4 SUB2016-00068

THE BROADWAY GROUP SUBDIVISION

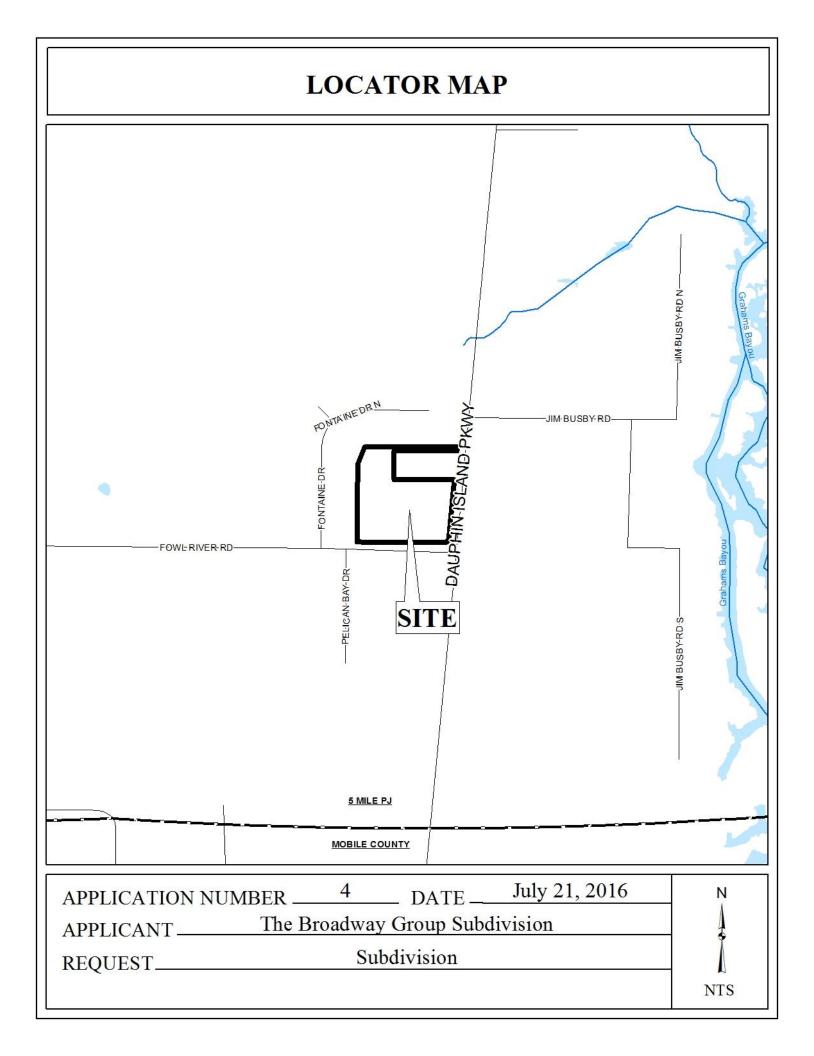
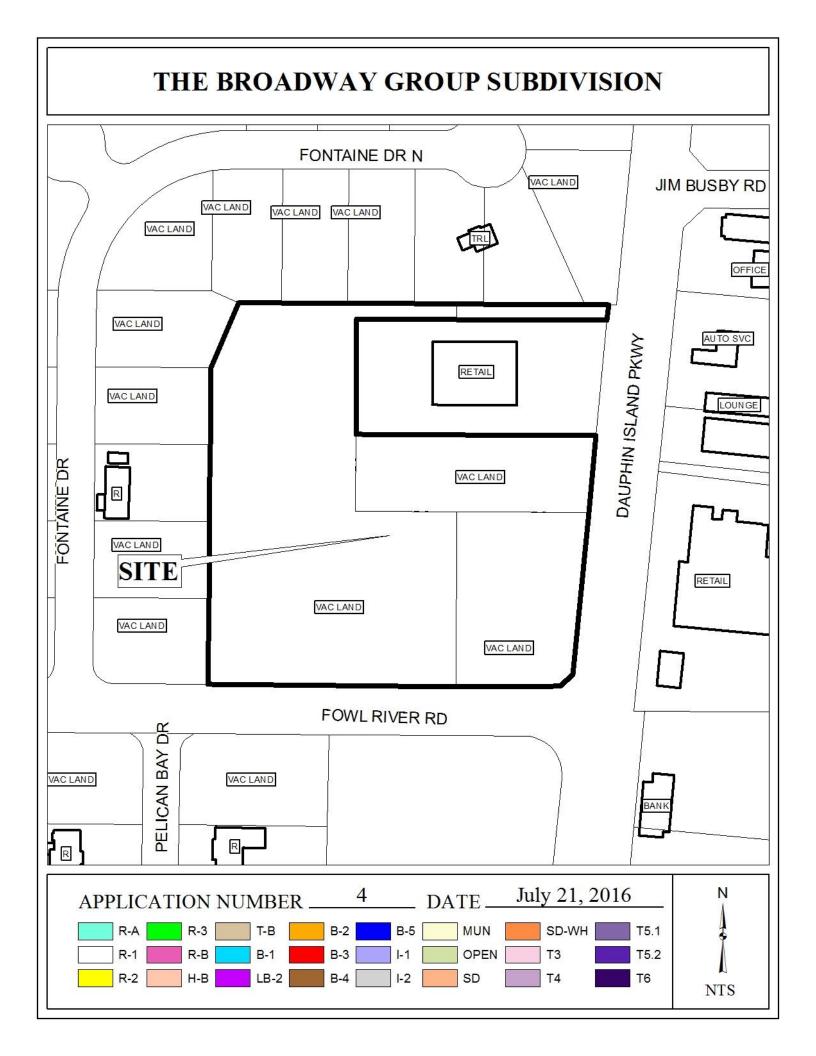
The site has frontage along Dauphin Island Parkway, a collector street, and Fowl River Road, a minor street without curb and gutter. As a collector street, Dauphin Island Parkway should have a minimum right-of-way of 70'; the preliminary plat illustrates a compliant right-of-way of 80', making no dedications necessary. Fowl River Road is illustrated as having an existing right-of-way of 60', making no dedications necessary. Dedication of the corner radii at Dauphin Island Parkway and Fowl River Road should be required per Section V.D.6. of the Subdivision Regulations.

Access management is a concern, therefore each lot should be limited to one curb cut per street with the size, location, and design to be approved by the Mobile County Engineering Department and conform to AASHTO standards.

The 25-foot minimum building setback line is not depicted. This should be illustrated for both lots, along all frontages on the Final Plat, if approved.

The lot size is indicated in square feet and acres on the preliminary plat and should be retained on the Final Plat, if approved.

There are two ingress/egress easements on the site, as well as an Alabama Power easement located on the site. If approved, a note should be placed on the Final Plat stating no structures shall be constructed or placed within any easements.

This site is located in the County, thus any lots which are developed commercially and adjoin residentially developed property must provide a buffer, in compliance with Section V.A.8. of the Subdivision Regulations. A note regarding this requirement should also appear on the Final Plat, if approved.

The plat meets the minimum requirements of the Subdivision Regulations and is recommended for Tentative Approval, subject to the following conditions:

- 1) dedication of the corner radii at Dauphin Island Parkway and Fowl River Road per Section V.D.6. of the Subdivision Regulations
- 2) illustration of the 25' minimum building setback line along all frontages;

- 3) placement of a note on the Final Plat stating that each lot should be limited to one curbcut per street with the size, location, and design to be approved by the Mobile County Engineering Department and conform to AASHTO standards;

- 4) retention of the lot sizes in square feet and acres, or provision of a table on the plat depicting the same information;
- 5) placement of a note on the Final Plat stating that any lots which are developed commercially and adjoin residentially developed property must provide a buffer, in compliance with Section V.A.8. of the Subdivision Regulations;

- 6) placement of a note on the Final Plat stating no structures shall be constructed or placed in any easements;
- 7) compliance with Fire comments (*Projects outside the City Limits of Mobile, yet within the Planning Commission Jurisdiction fall under the State or County Fire Code.* (2012 IFC).) and

- 8) placement of a note on the Final Plat stating that development will be designed to comply with the stormwater detention and drainage facilities of the City of Mobile stormwater and flood control ordinances, and requiring submission of certification from a licensed engineer certifying that the design complies with the stormwater detention and drainage facilities of the City of Mobile stormwater and flood control ordinances prior to the issuance of any permits. Certification to be submitted to the Planning and Zoning and County Engineering.
